**Enclosure 1**

**Change Pages for Mixed Oxide Fuel Fabrication Facility  
Construction Authorization Request**

Figure 11.9-34. Uranyl Nitrate System

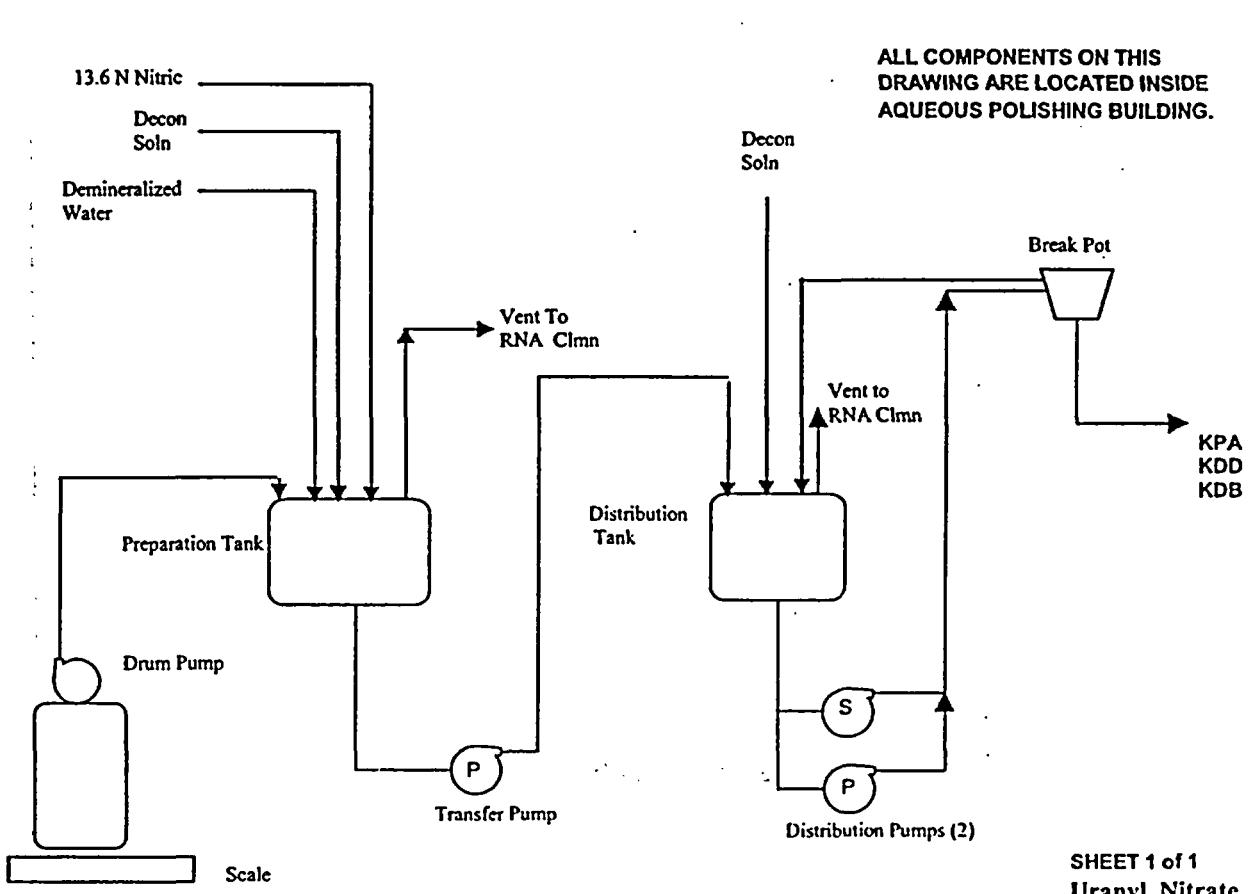
Figure 11.9-34 provides a schematic of the Uranyl Nitrate System.
